4. Electrification Technologies

Project Feedback

2019 ANNUAL MERIT REVIEW, VEHICLE TECHNOLOGIES OFFICE

Figure 4-1 – Presentation Number: elt089 Presentation Title: Assessing the North American Supply Chain for Traction-Drive Inverters, Motors, and Batteries for Class 3-8 Hybrid Electric and Plug-In Electric Commercial Vehicles Principal Investigator: Chris Whaling (Synthesis Partners)

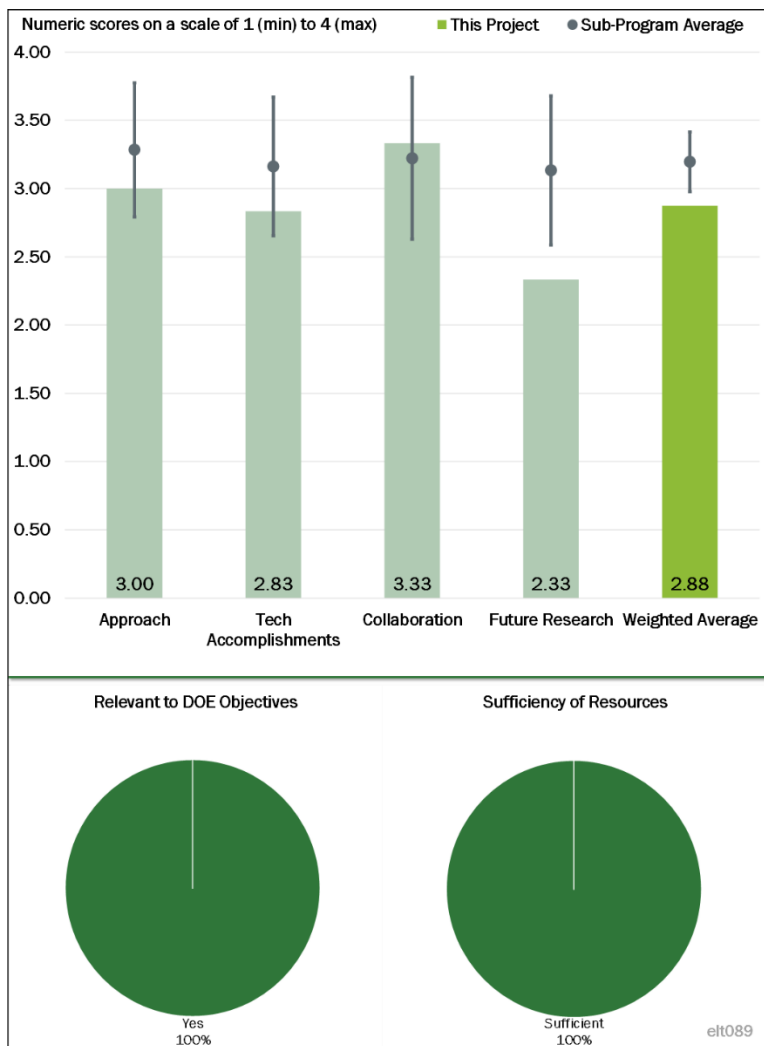
The reviewer detailed that the project uses a five stage approach including: developing specific customer questions with regards to their business, supply chains, future plans, technology gaps, constraints, bottlenecks, etc.; collecting data through primary (interviews) and secondary (literature) resources; modelling, including quantitative and qualitative data analysis; conducting technical analysis with regards to cost, trends, and gaps; and preparing reports. The reviewer said one focus of the project is to develop previously unidentified data and make it public, with most of the analysis being subjective and qualitative. The reviewer remarked it would have been beneficial if some additional insight into the domain modelling processes were provided. Given that much of the data collected are heterogeneous, it is likely there are a number of different paths that could have

The reviewer noted that besides Synthesis Partners, the project does not have any other team members. It was not mentioned whether any collaboration/coordination/engagement with other similar firms or research was undertaken to explore different means of establishing the project approach and in collecting, organizing, analyzing, and presenting the data. The reviewer said in short, it may have been beneficial to seek some additional perspectives in these areas as it may have uncovered other beneficial approaches to increase the project's value add.

Figure 4-2 – Presentation Number: elt090 Presentation Title: Dual-Phase, Soft Magnetic Laminates for Low-Cost, Non-Reduced Rare-Earth Containing Electrical Machines Principal Investigator: PR Subramanian (GE Global Research)

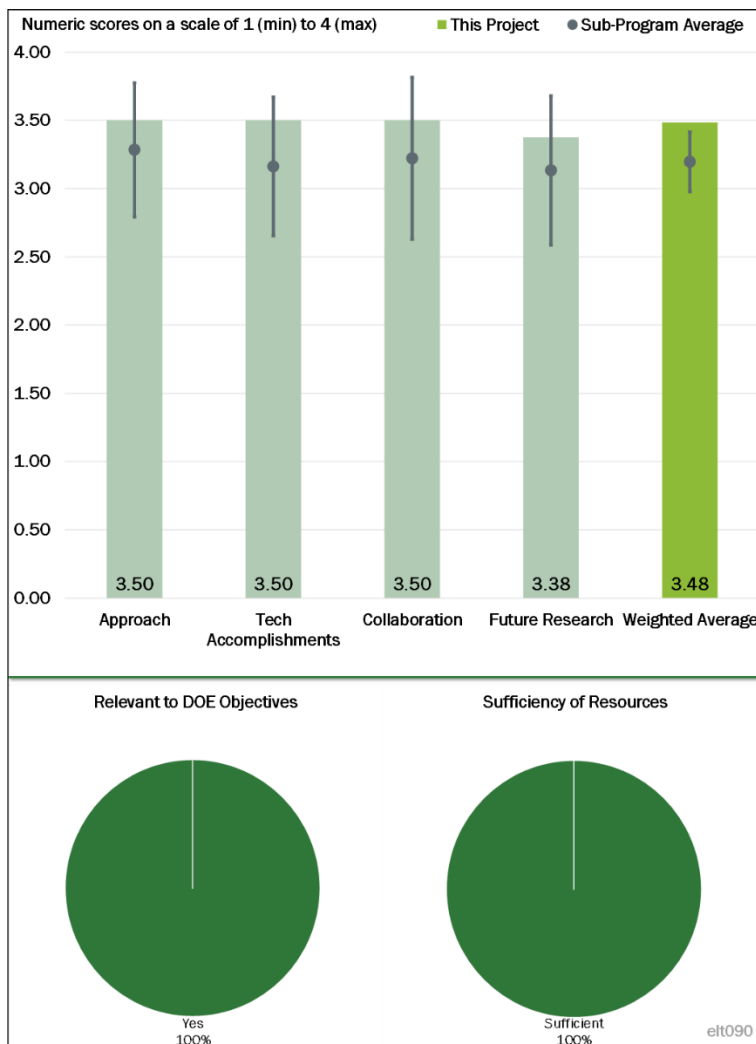
The reviewer asked why the flux barriers were stamped out and only the bridges made non-magnetic, and wondered why not keep the flux barriers as a non-magnetic steel region. Much higher speeds could most likely be obtained.

The reviewer said the project appears to have accomplished the objective to demonstrate the manufacturability of the dual-phase laminate material. A key question would be the cost impact on the overall motor.

The reviewer remarked the major remaining project task is the full scale prototype assembly and testing and some material property measurements. These appear to be feasible for the remaining project period of fiscal year (FY) 2019. The reviewer hoped that there is a market development plan for the material that results in it being available.

Figure 4-3 – Presentation Number: elt091 Presentation Title: Cost-Effective 6.5% Silicon Steel Laminate for Electric Machines Principal Investigator: Jun Cui (Iowa State University)

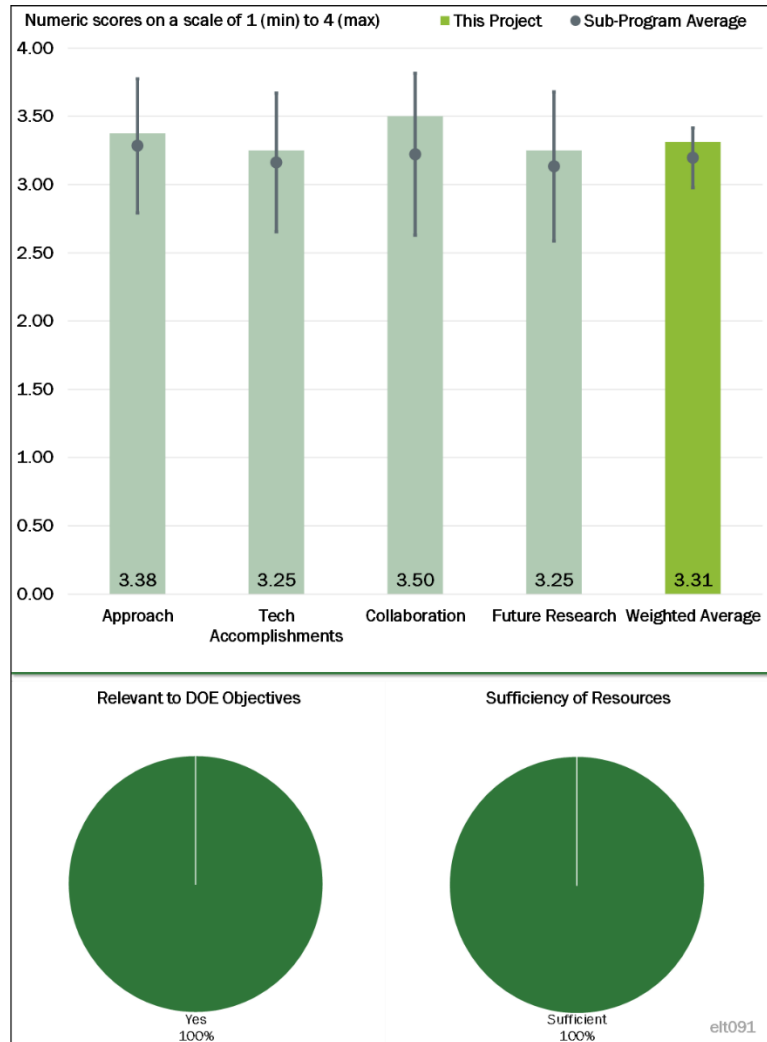
Reviewer 2:
 The reviewer said the project appears to have made progress towards the project objectives in the three key areas of magnet development, Si steel development, and motor development. The reviewer noted the phase 2 motor build appears to use existing commercially available materials, but the phase 3 build appears to focus on

The reviewer was not very clear about future plans.

Figure 4-4 – Presentation Number: elt092 Presentation Title: Wound Field and Hybrid Synchronous Machines for Electric Vehicle Traction with Brushless Capacitive Rotor Field Excitation Principal Investigator: Ian Brown (Illinois Institute of Technology)

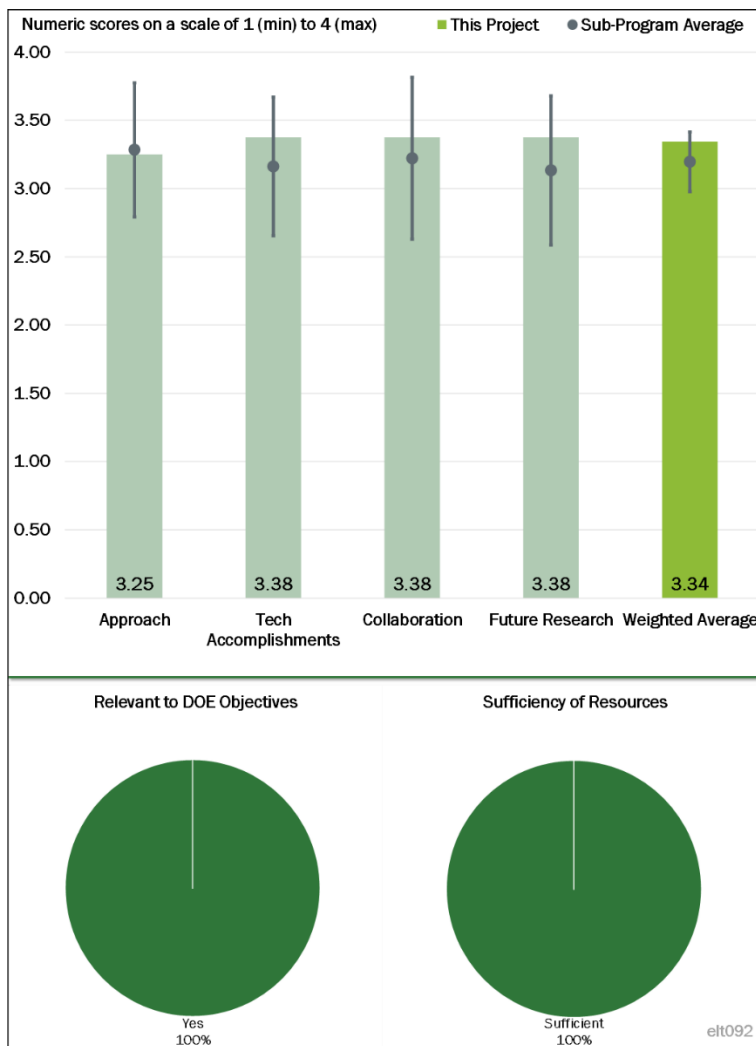
Reviewer 4:
 The reviewer remarked there are so many things that have been tried and it is somehow difficult to quantify the impact of each of them. The reviewer pointed out that the test results of the down-selected prototype will be helpful in that regard.

The reviewer remarked the proposed plan seems to address the remaining questions and barriers. The reviewer will be extremely curious to look at the final test results of the full power dynamometer testing.

The reviewer remarked some aspects are relevant, but a fair comparison to a baseline IPM is needed. Also, testing the prototype will help confirm the analysis results as well as show any unforeseen issues

Figure 4-5 – Presentation Number: elt093 Presentation Title: High-Speed Hybrid Reluctance Motor with Anisotropic Materials Principal Investigator: Edwin Chang (General Motors)

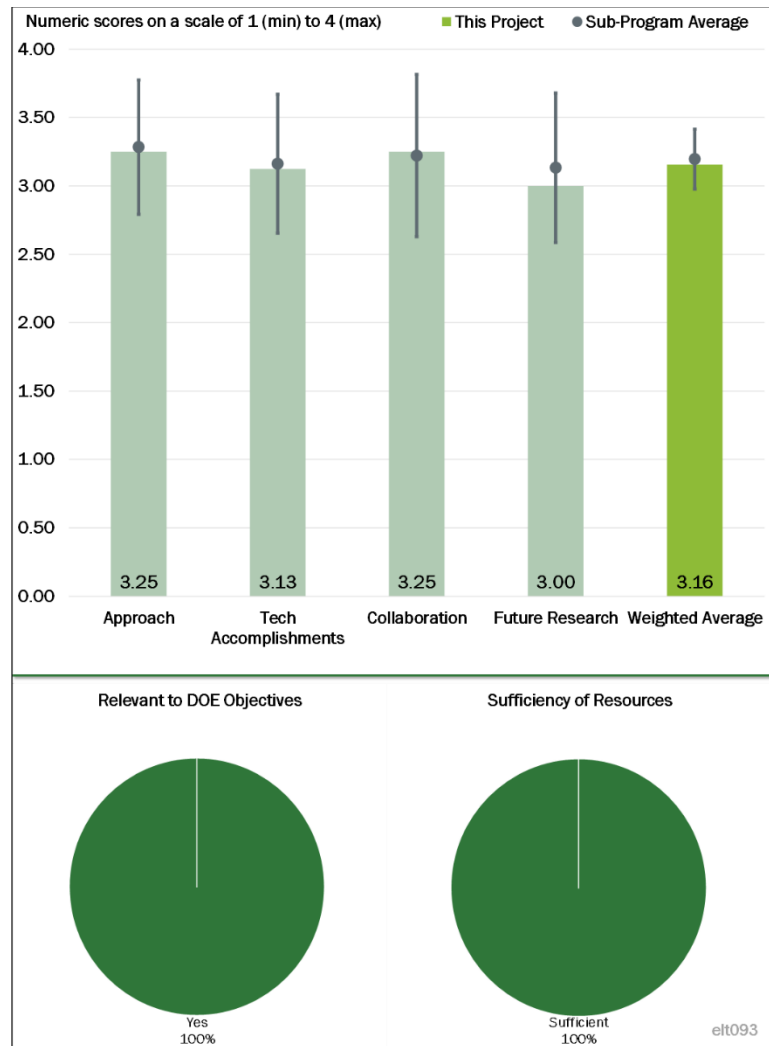
Reviewer 1:
 The reviewer said the project summarizes three potential motor designs and provides a nice and clear summary of the performance comparison. The project highlights the motor variations that do not meet the cost targets, and also includes a pie chart showing a rough comparison of the relative costs within the motor. The reviewer

The reviewer remarked that test results (including burst test and life testing) will be critical to verify the analysis results.

Figure 4-6 – Presentation Number: elt094 Presentation Title: Development and Demonstration of Medium- and Heavy-Duty Plug-In Hybrid Work Trucks Principal Investigator: John Petras (Odyne Systems)

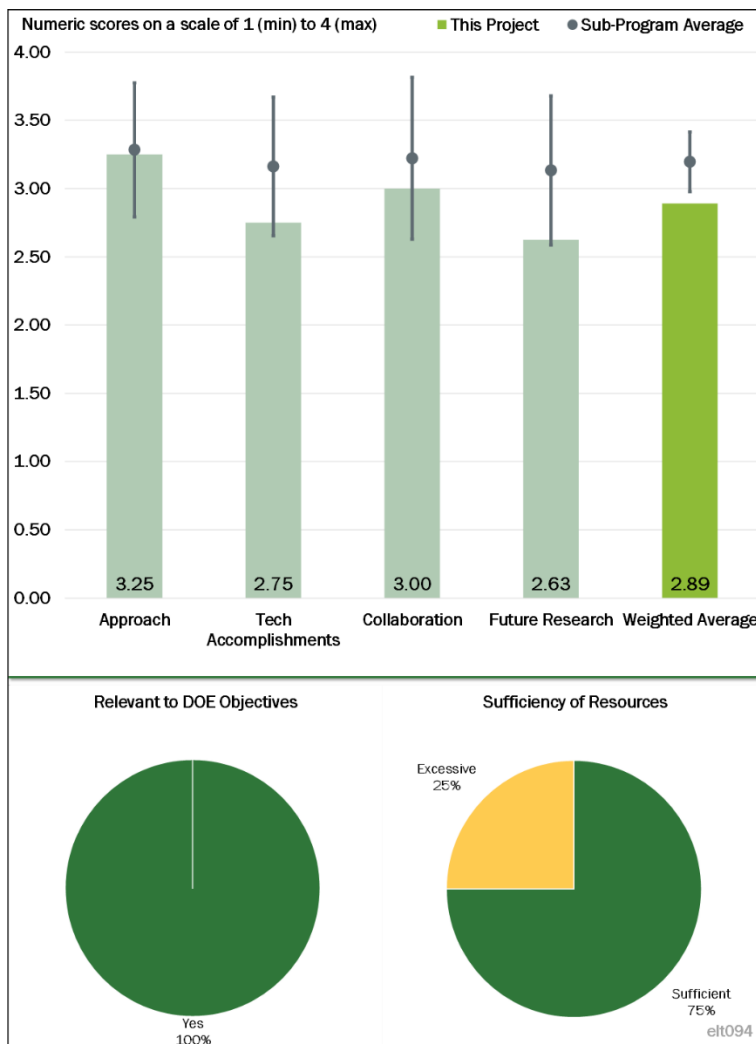
The reviewer stipulated that work trucks are unique in the proportion of fuel used during stationary activity and the diversity of vehicle design and jobsite equipment utilized to fulfill their missions. An excellent attribute of

OEMs and Tier 1's are not interested due to low volume. Unfortunately, due to low volumes, available modules, and the difficulties of packaging a modular system, quoted battery prices are in the \$800-\$850/ kWh range. The reviewer noted that two battery systems (Torqeedo 11.5 kWh and Octillion 14.9 kWh) have been selected and are currently undergoing evaluation with a continuous power target of greater than 30 kW. The reviewer pointed out that a question arises due to the high cost of the batteries (which will need to be periodically replaced) and the need to achieve a competitive lifecycle return on investment. It is probably water over the dam now, but it may have been beneficial to have first scoped the specs (including costs) and availability of battery technologies and then used that information to inform the team's battery requirements (without compromising customer requirements). In this way, according to the reviewer, a system design may have been feasible that could incorporate widely available/cheaper battery technologies without being overly detrimental to vehicle performance. If this is possible, it may have gone a long way to improving overall system return on investment (ROI) and marketability.

The reviewer found that the major technical accomplishments are excellent: First, Parker motor and Chelsea extended PTO; second, integrated charger, direct current (DC)/DC inverter and export power unit; and third, integration of the air conditioning with the chassis system eliminating secondary blower/evaporator and compressor. However, remarked the reviewer, there was no energy budget analysis to show how these particular technical accomplishments achieved either in theory or in testing incremental reductions in fuel consumption or progress towards the 50% reduction goal

Figure 4-7 – Presentation Number: elt095 Presentation Title: Vehicle-to-Grid Electric School Bus Commercialization Project Principal Investigator: Dennis Whitaker (Blue Bird Corporation)

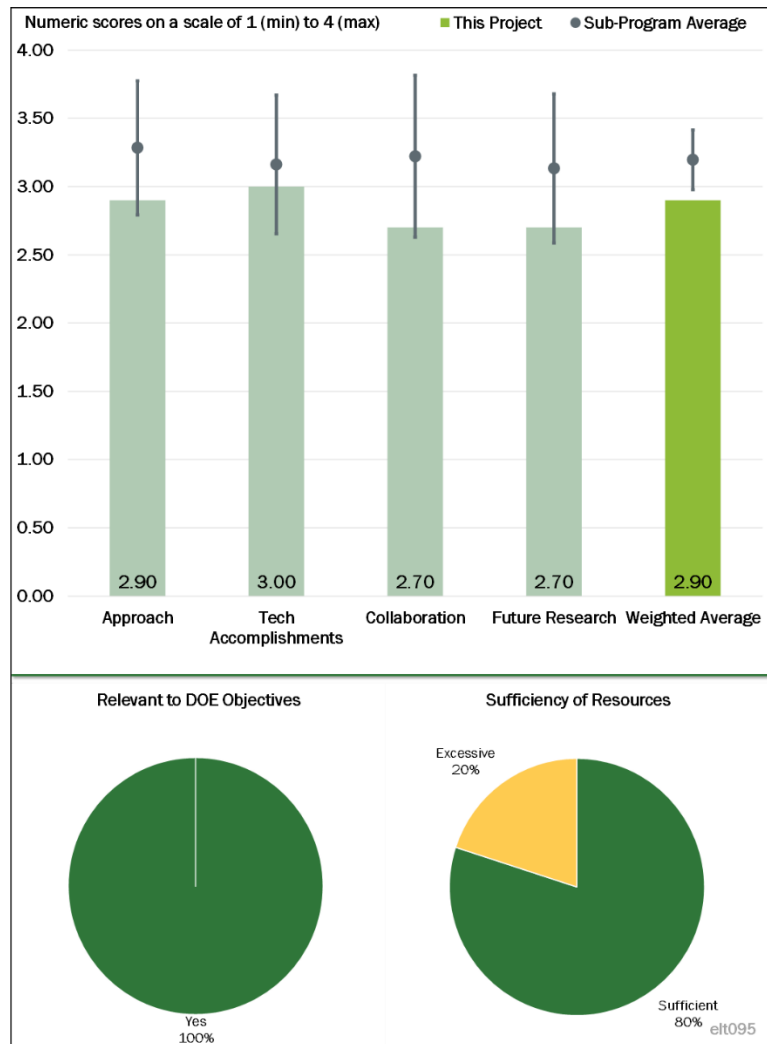
Reviewer 2:
 The reviewer detailed the overall objective of this project is to create a compelling value proposition for electric school buses based on a competitive total cost of ownership. This includes equipping an electric school bus with vehicle to grid (V2G) and vehicle-to-bus (V2B) income generating grid integration capabilities and advancing the technical maturity of selected medium-duty electric components to achieve superior energy efficiency and reduce operating costs. A fundamental assumption underlying the project is that a competitive total-cost-of-ownership can be achieved for an electric school bus through optimization of three parameters including bus capital cost, bus operating cost, and revenue generated from grid integration. The reviewer noted a high level barrier identified includes cost/performance tradeoffs for heavy-duty EVs that have not yet been thoroughly mapped out. In addition, the design of high-power charging systems is lagging where components for high-power AC charging are only appearing slowly and the pathway to conform with existing and emerging standards is not well established.

The project’s approach appears very practical, being focused upon cost/benefit tradeoffs and intent for marketability and commercialization. However, in support of this approach, it would be beneficial if on-going system cost analyses were being conducted to gauge progress toward cost effectiveness and provide the reviewer with greater confidence that progress toward ultimate marketability and competitive ROI was being achieved. In other words, establishment and periodic evaluation of a series of cost metrics throughout the project lifecycle. Additionally, little mention is made of the energy storage component (batteries) which will play a critical role in the efficiency and cost effectiveness of the system. The reviewer found that overall though, the project is well designed and clearly feasible.

The reviewer remarked a DC bi-directional charging could offer the overall arching target of vehicle weight and packaging. It is not clear why the project is not utilizing the DC charging architecture approach defined in SAE J1722 and commercialized. The reviewer said an analysis relative to justifying the V2G implementation is lacking to demonstrate the overall benefits for the added cost of the system versus the ROI.

The reviewer remarked while the technical accomplishments (increase regeneration braking capacity, reduce wheel size, lighter weight, etc.) per se are excellent, the progress in achieving the goal was not demonstrated. The reviewer said there should have been an itemized energy analysis to show how each accomplishment contributed incrementally to the goal of achieving an energy efficiency of 1.32 kWh/mile (1/2 way mark) from the original baseline of 1.53 kWh/mile.

The reviewer remarked not enough analysis and planning went in before this project started to think about the cost-benefits of bi-directional charging. While the merits of bi-directional charging are anecdotal, a cost-benefit analysis should have been done beforehand to determine if the return of energy to the grid balances energy taken out from the grid. The reviewer said, if not, then are the costs of bi-directional charging justified by the credits for return of electricity to the grid, and how much does the use cycle of the V2G electric school bus match the power consumption cycle of the electric grid. The reviewer asked, if not worthwhile, then can the components, subassemblies, and integration for bi-directional charging be dropped to save money on the total cost of ownership (TCO) of the electric school bus (i.e., make the bus one-way only charging). The reviewer said it is not too late to determine whether the project is worthwhile to be saved.

Figure 4-8 – Presentation Number: elt158 Presentation Title: Zero-Emission Cargo Transport II: San Pedro Bay Ports Hybrid & Fuel-Cell Electric Vehicle Project Principal Investigator: Joseph Impullitti (South Coast Air Quality Management District)

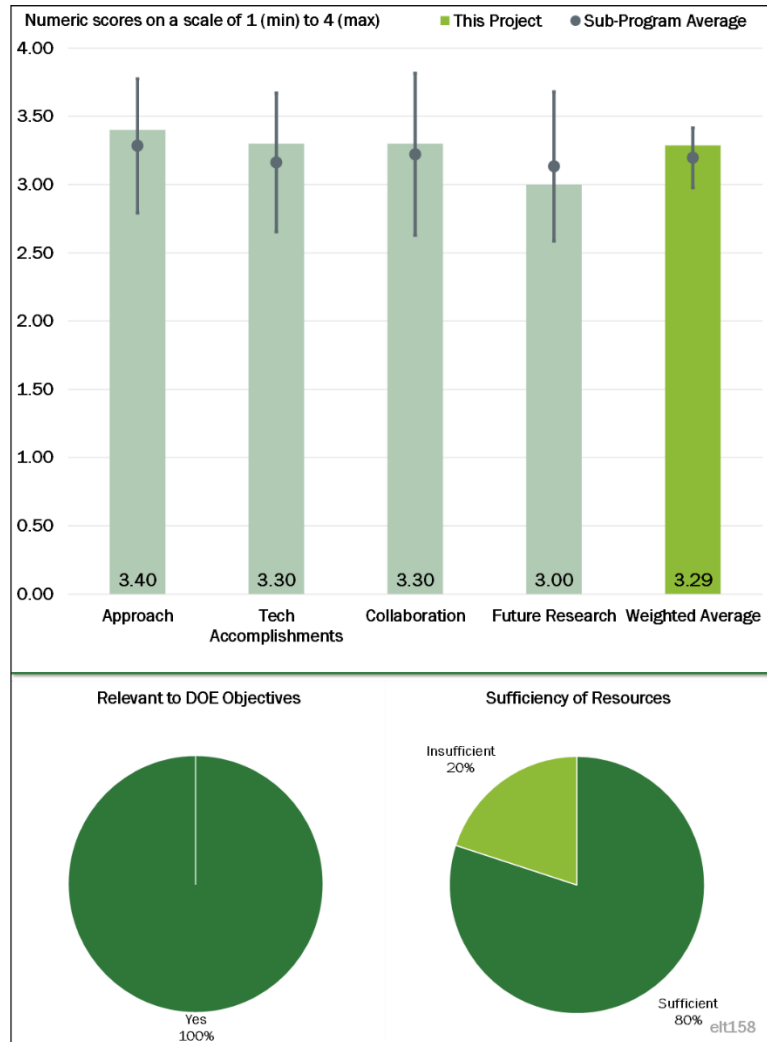
Reviewer 4:
 The reviewer said the overall approach to this project was to develop and deploy seven zero- or near-zero-emission cargo transport vehicles. The reviewer believed it was a good decision to partner with a variety of manufacturers/developers and integrators to develop the different trucks. The specific approach during the current review period was largely to complete the vehicle builds, perform shakedown testing/troubleshooting and to commission/deploy the vehicles into operation when ready. The reviewer found that this seems appropriate as the project nears completion.

The reviewer said that collaboration seems good; as previously stated, it is good to have multiple manufacturers/developers and integrators involved. The one potential improvement area the reviewer identified would be better coordination for consistency in pre-commissioning testing of the trucks. It would also be desirable (perhaps as part of the future work plan) to get manufacturer input on the expected production costs for these trucks based on today (if they were to be scaled up to comparable production volumes as conventional cargo transport truck production), in addition to any anticipated pathways to bringing these costs down.

The reviewer said the objectives outlined for the remaining challenges and future work are consistent with the objective of the project. The reviewer remarked it would be useful to establish a timeline and roadmap for the remaining tasks. Whereas the scope of the project is mainly deployment and data collection, it is unclear whether there is a long-term plan beyond this initial demonstration.

The reviewer and the rest of the industry is very excited to now get reports on the performance of these trucks; uptime, fuel use, driver satisfaction, etc. But there was little evidence that there is the budget for time and money. When asked by a reviewer, the answer was that the team hopes we have funding to do a proper evaluation. The reviewer sure hopes we can find the means to or the success of this program will be greatly diminished. The reviewer hopes to see results either in the 2020 VTO Annual Merit Review (AMR) or by other means.

Figure 4-9 – Presentation Number: elt187 Presentation Title: Comprehensive Assessment of On- and Off-Board, Vehicle-to-Grid Technology Performance and Impacts on Batteries and the Grid Principal Investigator: Sunil Chhaya (Electric Power Research Institute)

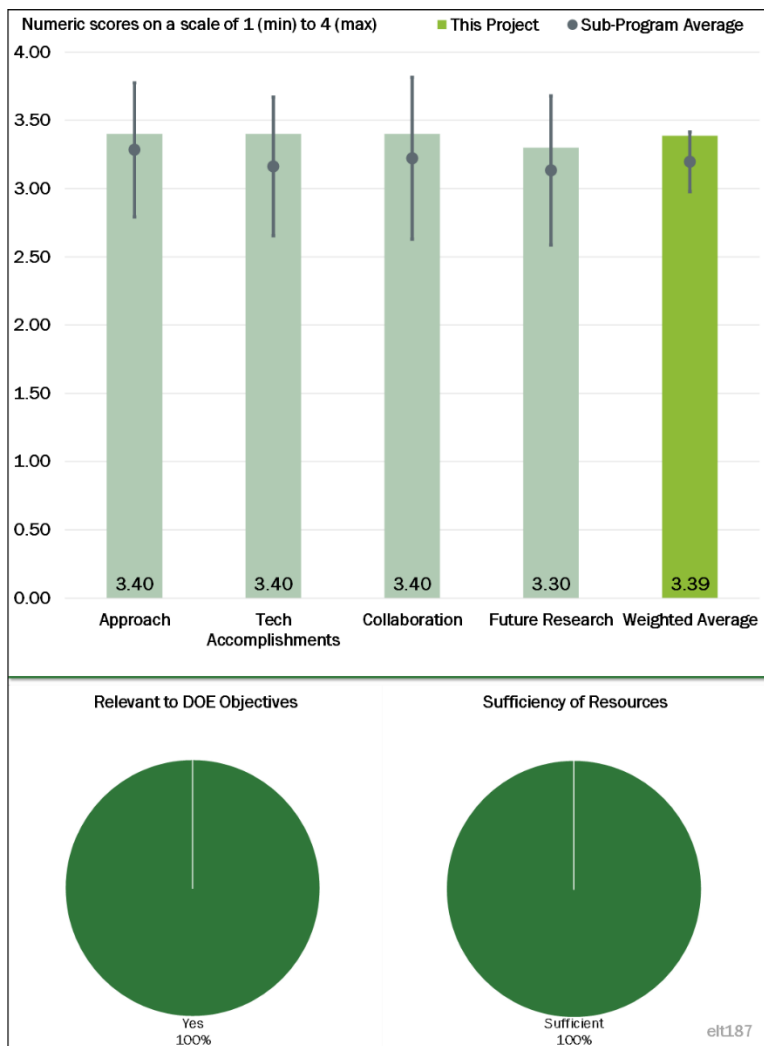
Reviewer 4:
 The reviewer commented that the proposed two standards-based architectures for V2G, which take both on-vehicle AC V2G and off-vehicle DC V2G into consideration, appear to be a good approach to address the barriers of on- and off-vehicle hardware (such as the bi-directional converters, and SPIN, etc.), and standards implementation.

The reviewer said the team does have a clear plan in place for future research, both under this project and after. The team correctly acknowledges that not all challenges/barriers identified will be addressed under this project. Particular attention is warranted for the battery durability testing that the team will be doing under this project, where the tasking has been reconfigured. The reviewer said that under these efforts, the team will be looking to identify the optimal discharge rate for ensuring battery durability, a very important question to ensure successful V2G operation.
